New Albany Architectural Review Board
Monday, May 11, 2026 Meeting Minutes - Approved

ARB-28-2026 Richmond Square Wall Certificate of Appropriateness

ARB-19-2026 New Albany Methodist Sign Certificate of Appropriateness and Waiver

ARB-30-2026 Church of the Resurrection Certificate of Appropriateness

Image: Proposed monument sign.

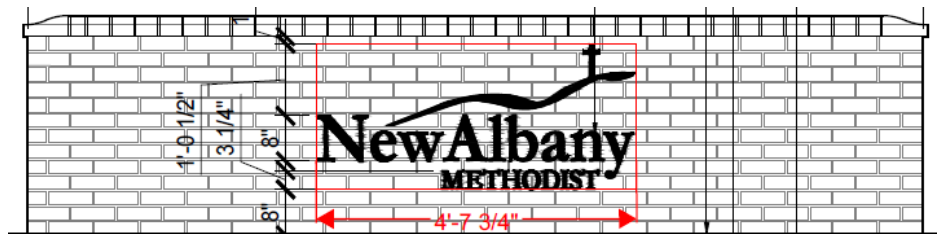
- The proposed monument sign serves the New Albany Methodist Church. It is a stainless-steel logo with a bead blast finish and LED halo lighting. This sign functions together with the existing brick wall as a monument sign.

- The proposed monument sign is to be located perpendicular to Third Street at the entrance to the New Albany Methodist Church site.
- C.O. Section 1169.02 provides definitions for the various sign types. It defines wall signs as being mounted directly on the building face, whereas it defines monument signs as being incorporated as part of an architectural feature whose base rests entirely on the ground and is wholly independent of any building for support. As such, this proposed sign is considered a monument sign.

- C.O. 1169.17(c) does not permit monument signs in the Campus sub-district of the Village Center. The applicant is requesting a waiver to allow the monument sign. For other sub-districts and use categories, the city sign code has the following requirements:

Approved

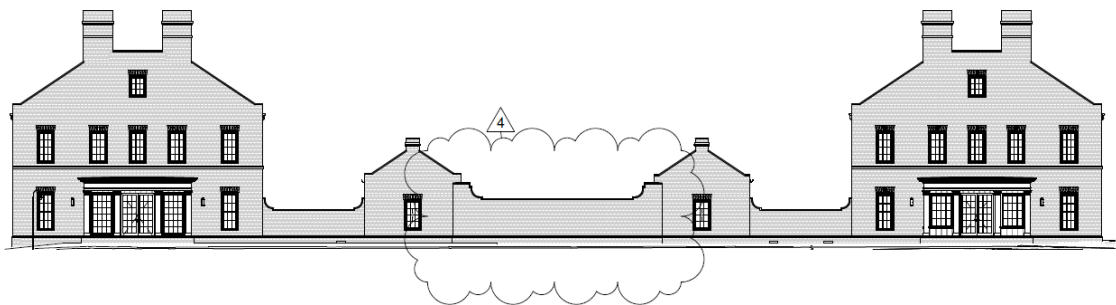
- The applicant proposes redesigning the brick wall along Main Street by eliminating the window well cutout, light fixtures along the brick wall, and altering the cap details.

- The brick wall is now proposed to feature a blank façade with a consistent height along Main Street between the two units. The previous design of the brick retaining wall was approved with a condition that states, “Guardrails at the window wells and iron work on the center Main Street retaining wall shall be subject to staff approval if required.” Since the new design proposal does not include these specific details as part of the condition of approval from ARB-106-2023, the application has come back to ARB for approval of the changes.

- The applicant has proposed to remove light fixtures, a window well cutout, and the proposed metal railing that were part of the previously approved brick wall.
